VIRGINIA ELECTRIC AND POWER COMPANY  
SURRY UNITS 1 AND 2  
REACTOR COOLANT SYSTEM LOADS  
AND  
COMPONENT SUPPORT MARGINS  
EVALUATION  
FOR  
ELIMINATION OF REACTOR COOLANT SYSTEM  
MAIN LOOP PIPE BREAK PROTECTIVE DEVICES

NOVEMBER 1985

REACTOR COOLANT  
PUMP SUPPORTS  
GENERAL ARRANGEMENT  
SURRY POWER STATION

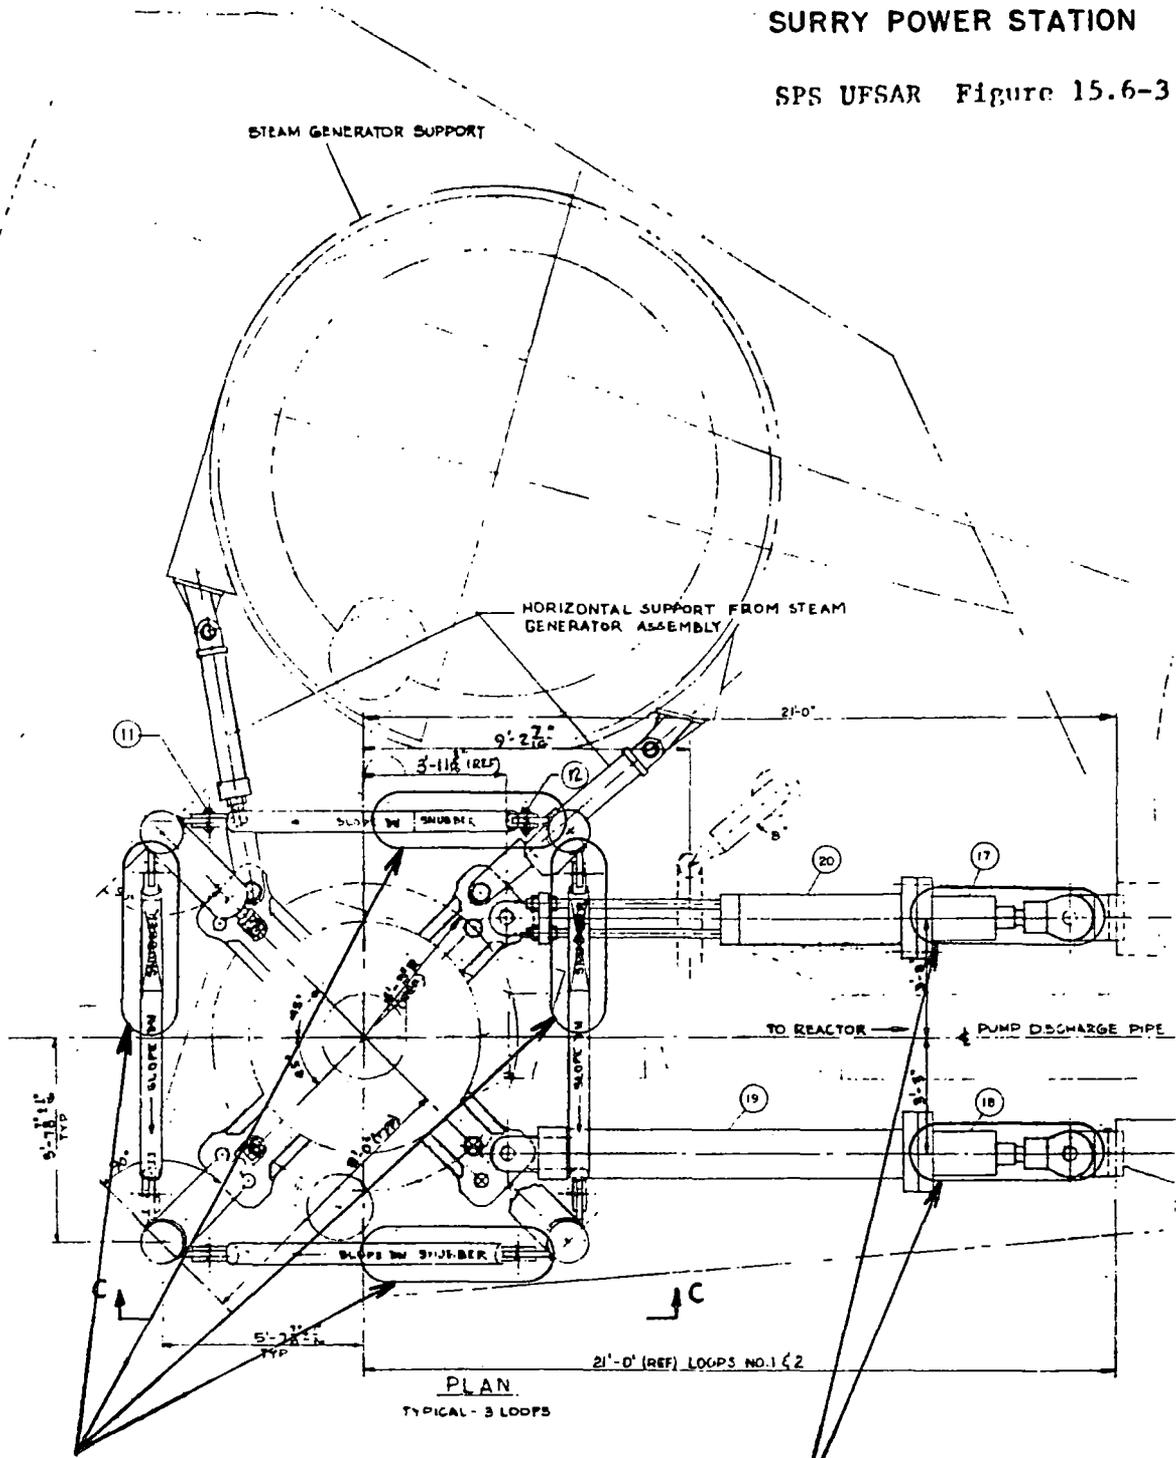
Four 4"-bore  
Bergen-Paterson  
snubbers to be  
eliminated

Two 12"-bore  
Bergen-Paterson  
snubbers to be  
eliminated

REACTOR COOLANT  
PUMP SUPPORTS  
GENERAL ARRANGEMENT  
SURRY POWER STATION

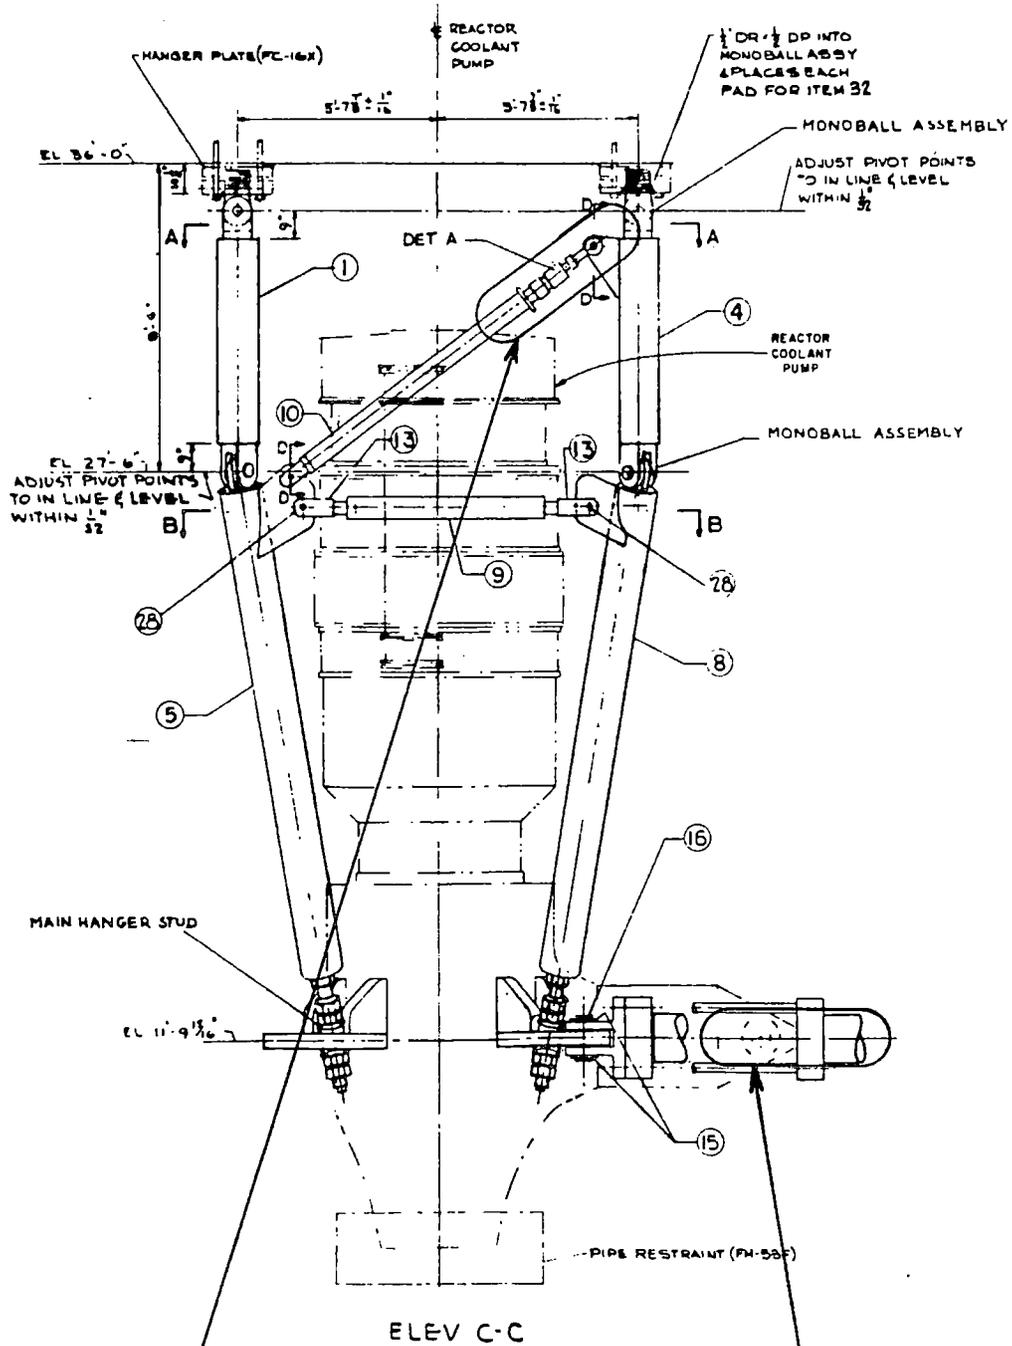
Four 4"-bore  
Bergen-Paterson  
snubbers to be  
eliminated

Two 12"-bore  
Bergen-Paterson  
snubbers to be  
eliminated

STEAM GENERATOR  
SUPPORT ASSEMBLY

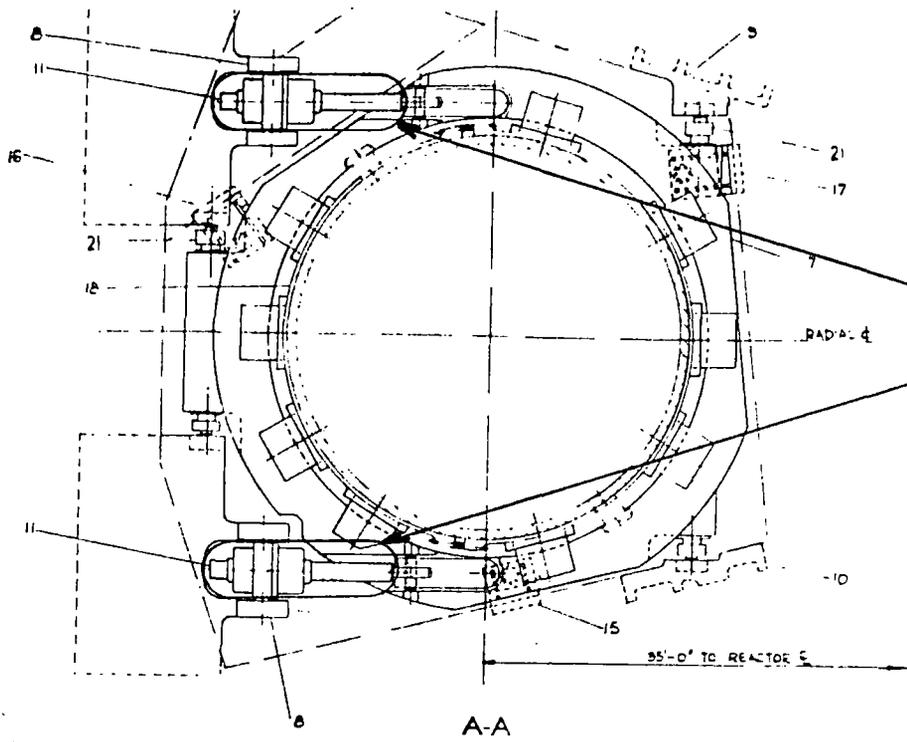
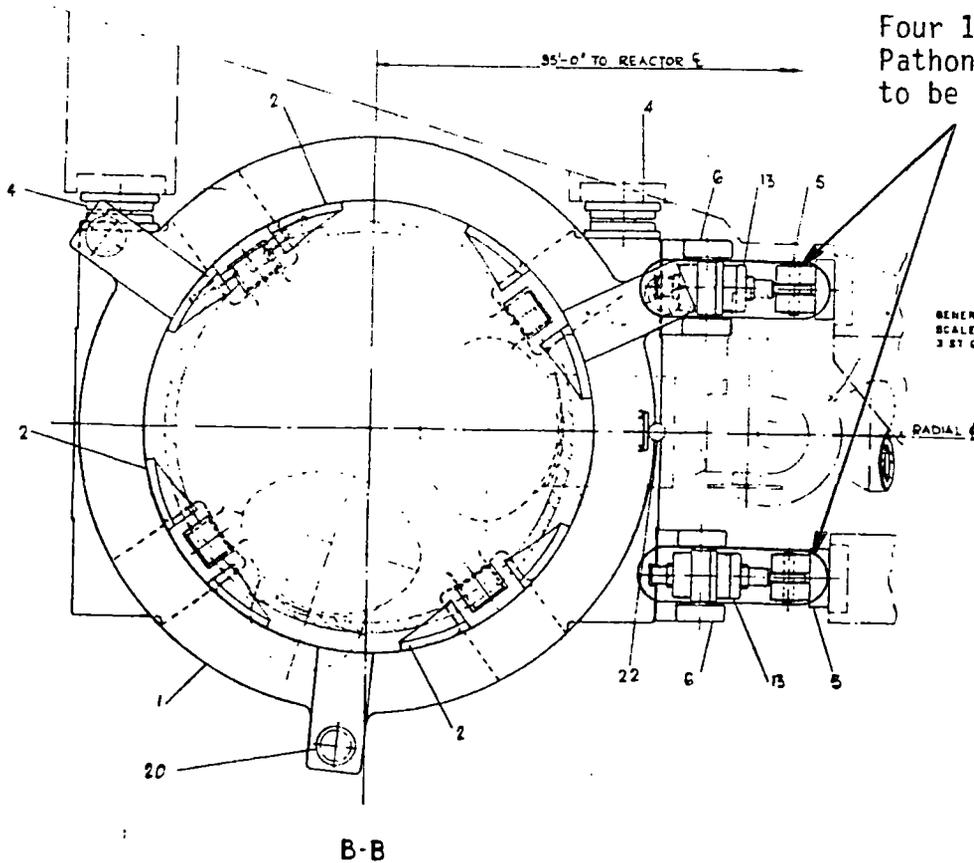
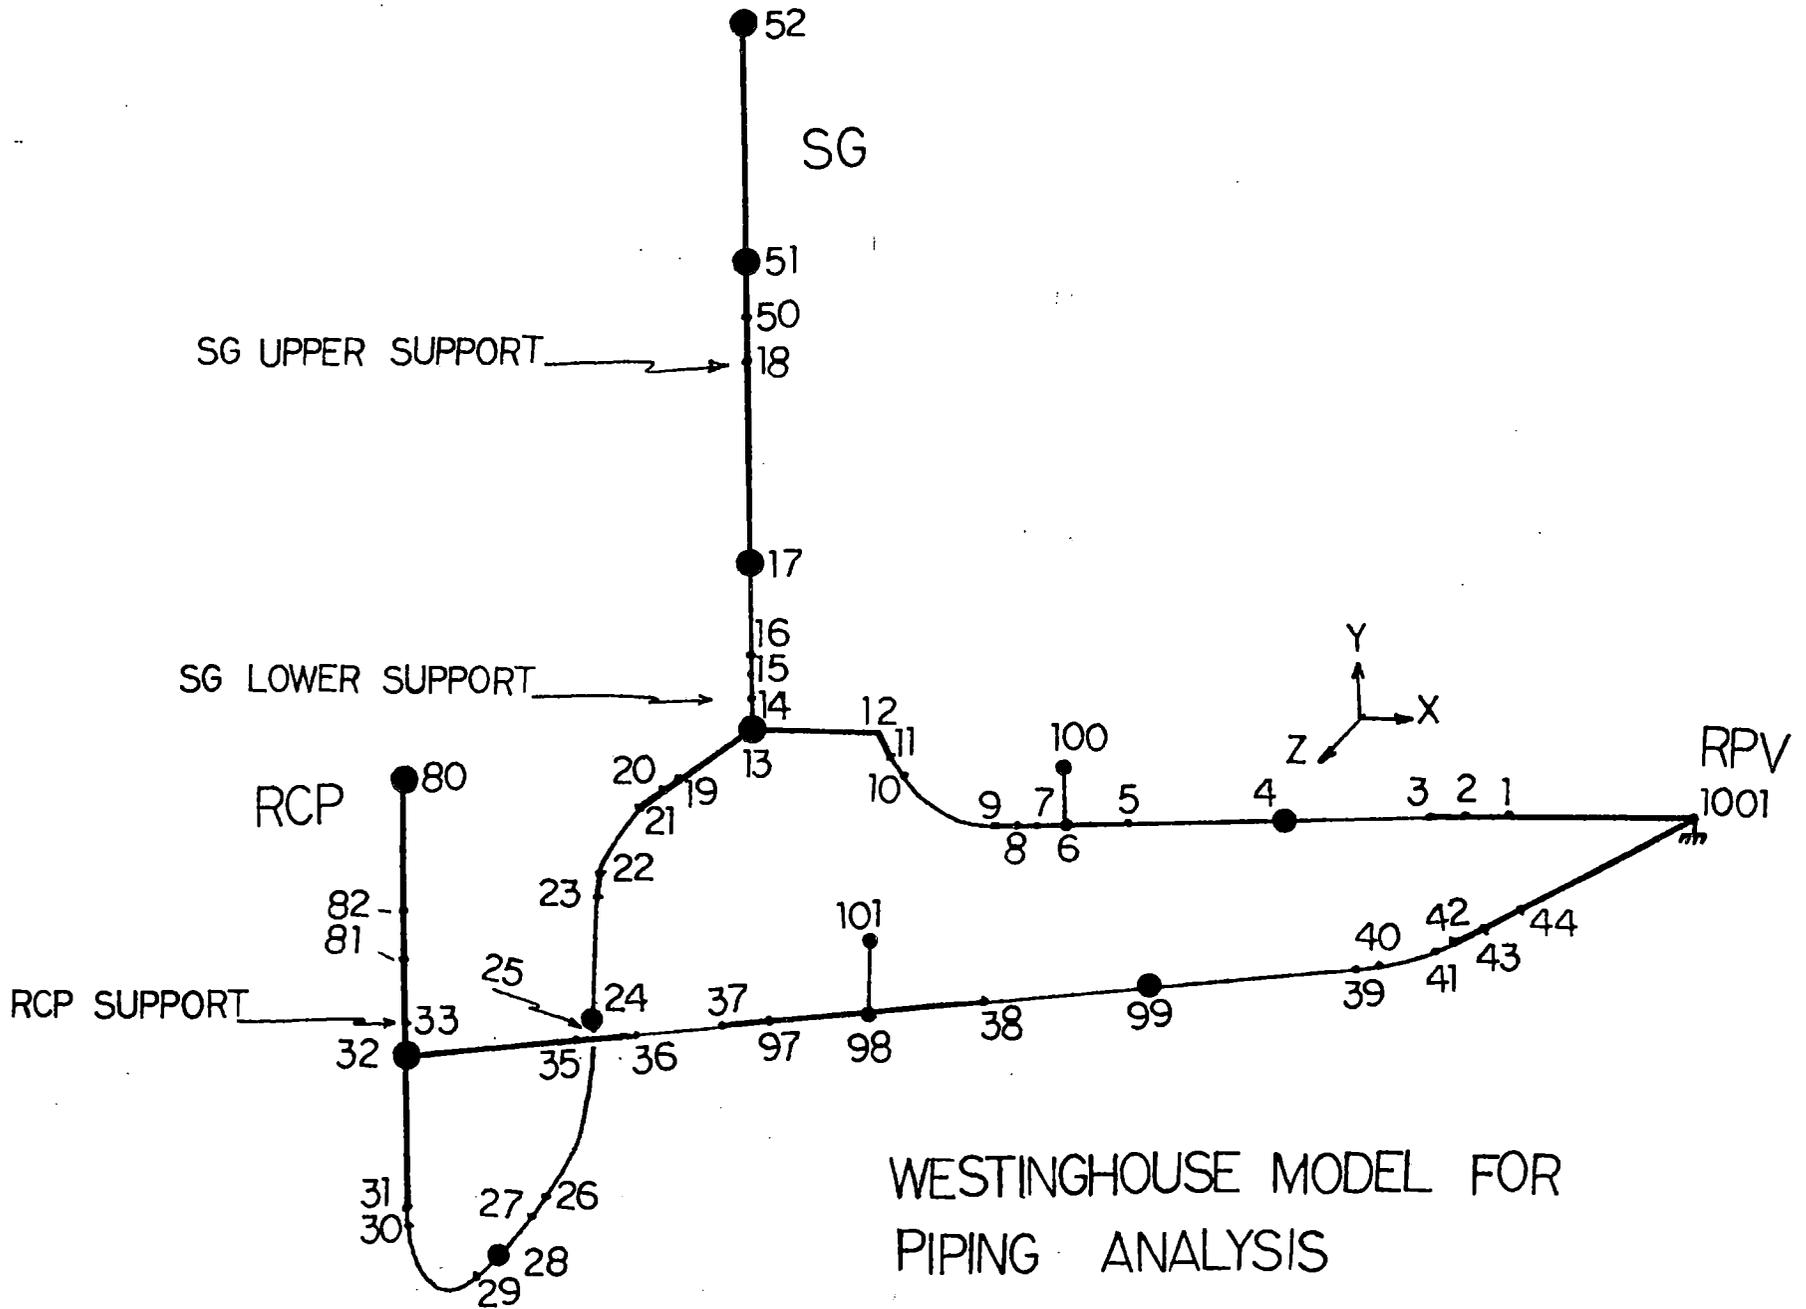
Four 12"-bore  
Pathon snubbers  
to be maintained

Four 12"-bore  
Pathon snubbers  
to be eliminated
